3980 Walker Road Site Development Plan Drainage Letter

Subdivision: Walker Reserve (Lot 3)

Revise to final
drainage report. Refer
to Chapter 4 for
guidelines

DRAINAGE MAP

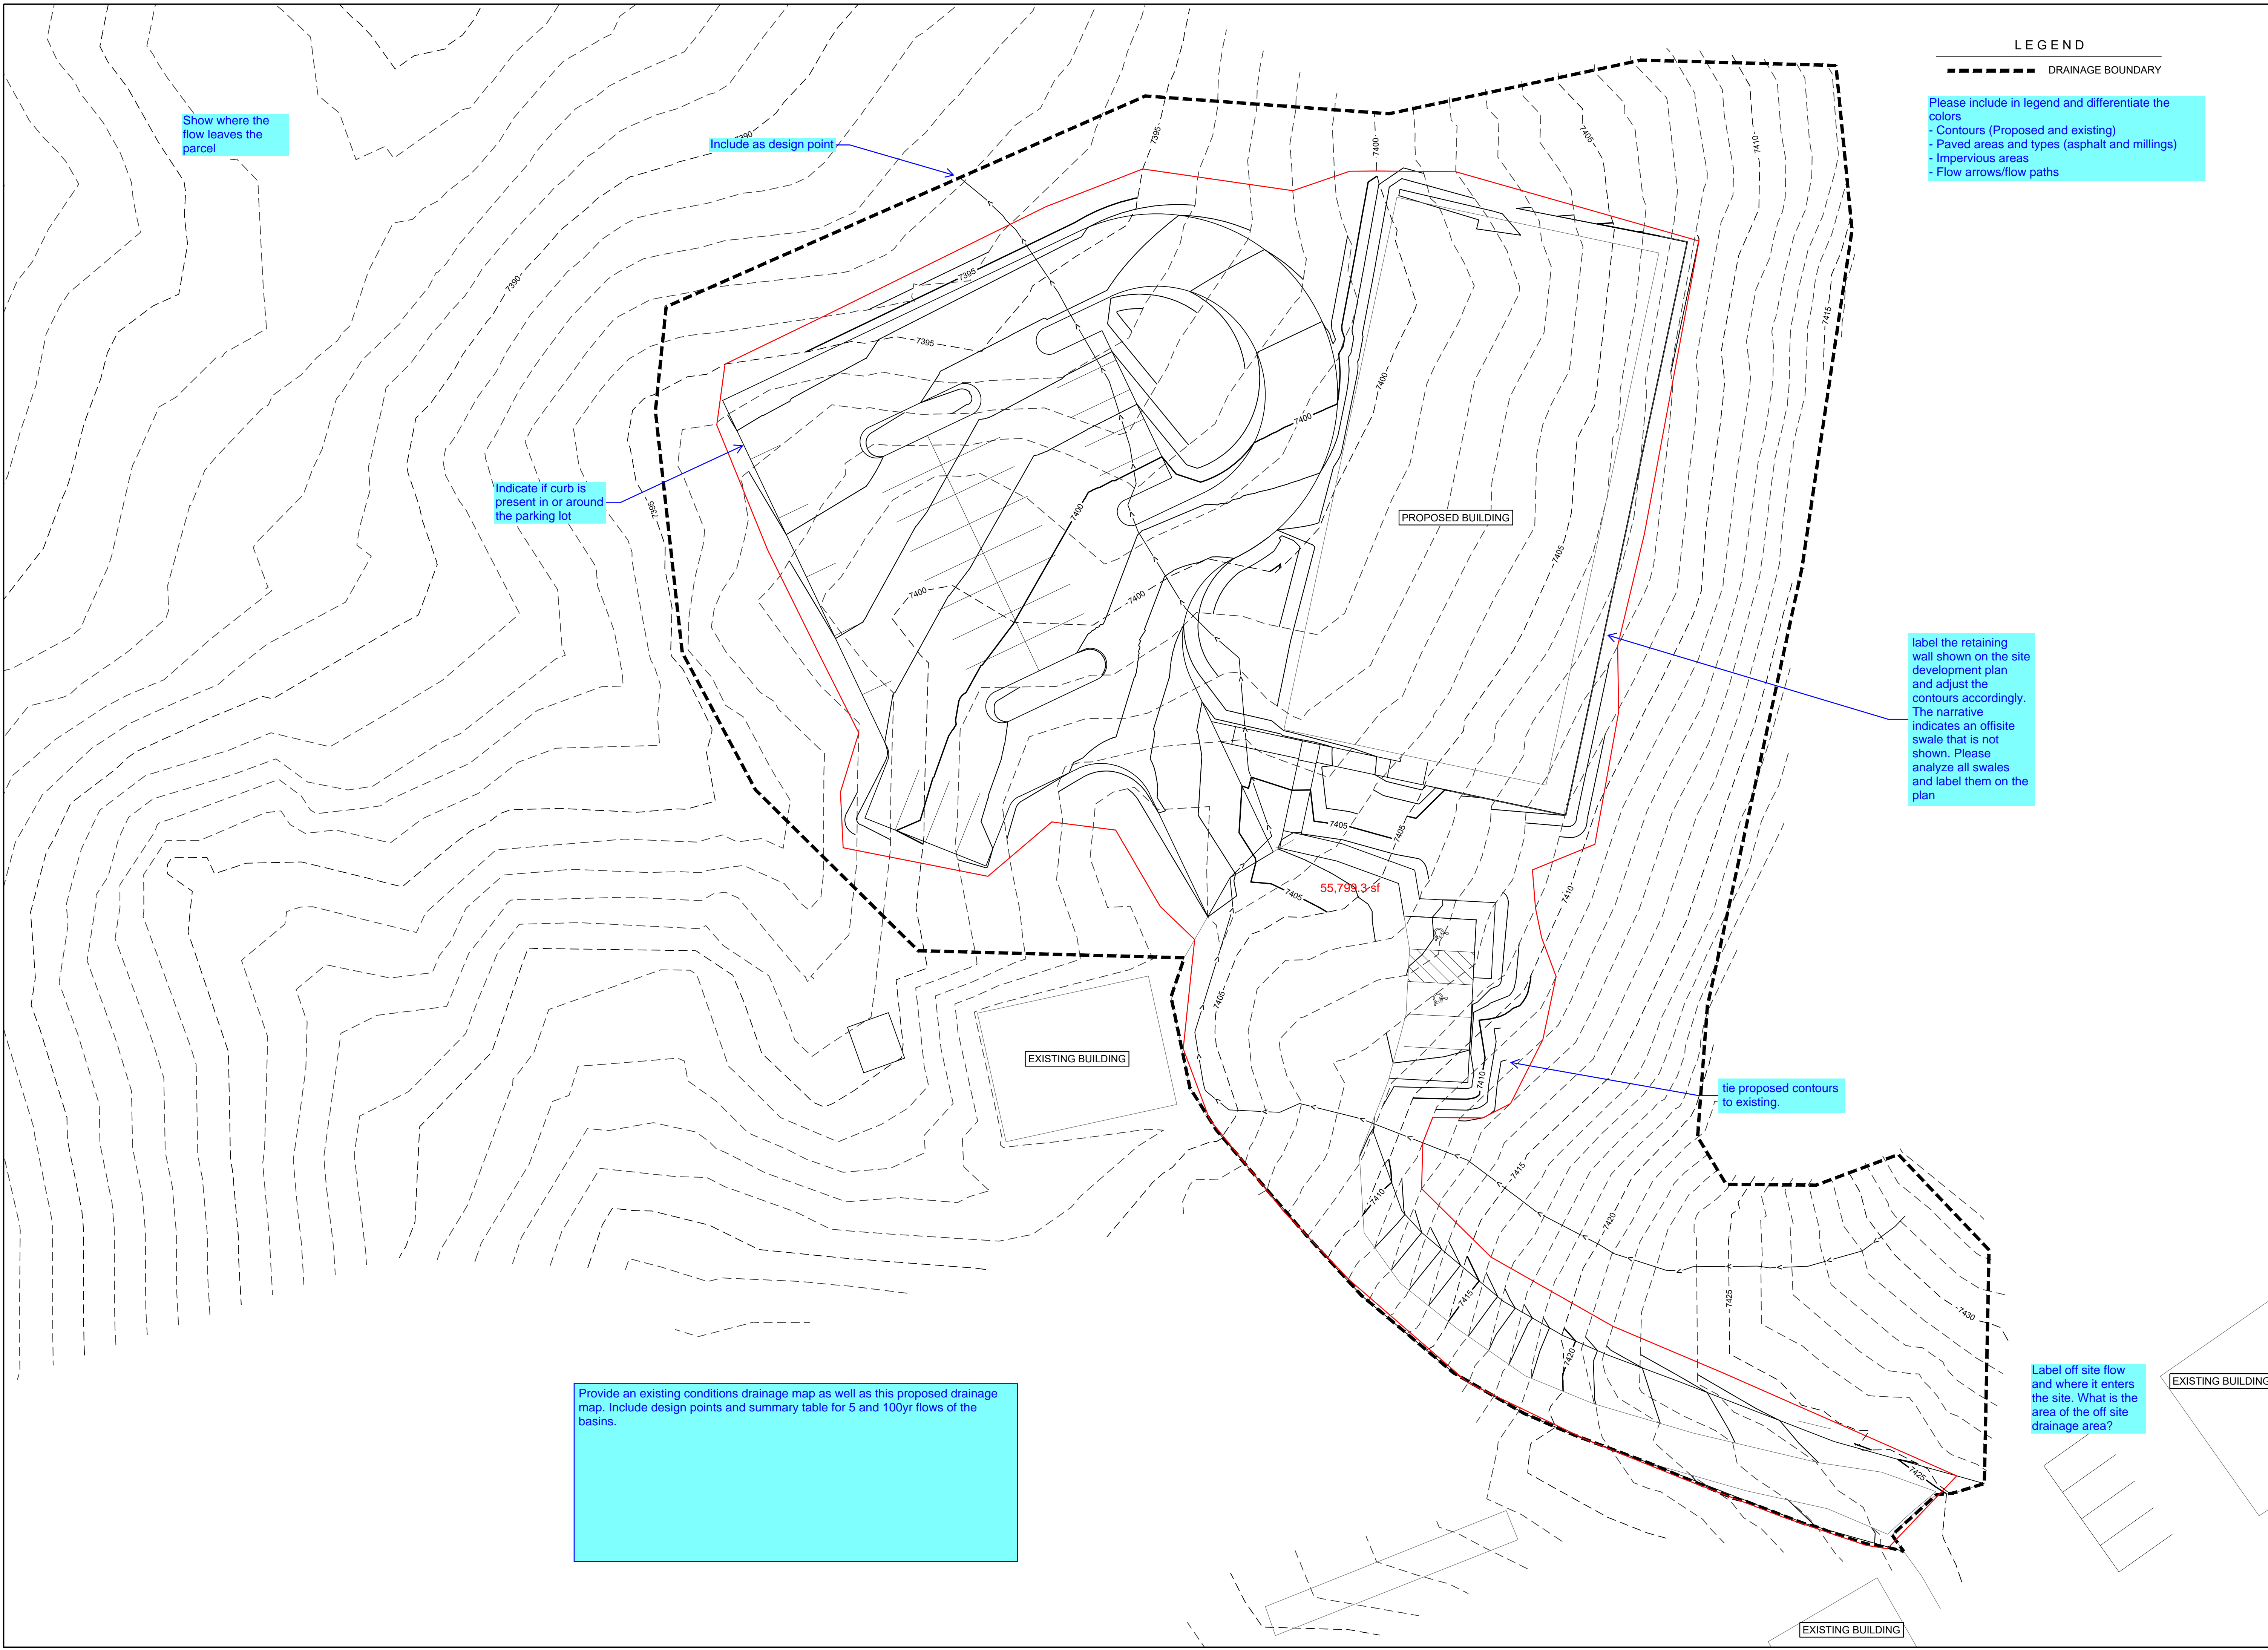
Please include and label this drainage swale on the drainage map.

Please include a design point and show on the map where the flow leaves the developed area and where the flow leaves the property

Please include in legend and differentiate the colors
- Contours (Proposed and existing)
- Paved areas and types (asphalt and millings)
- Impervious areas
- Flow arrows/flow paths

Show where the flow leaves the parcel

Include as design point

Indicate if curb is present in or around the parking lot

label the retaining wall shown on the site development plan and adjust the contours accordingly. The narrative indicates an offsite swale that is not shown. Please analyze all swales and label them on the plan

tie proposed contours to existing.

Label off site flow and where it enters the site. What is the area of the off site drainage area?

Provide an existing conditions drainage map as well as this proposed drainage map. Include design points and summary table for 5 and 100yr flows of the basins.
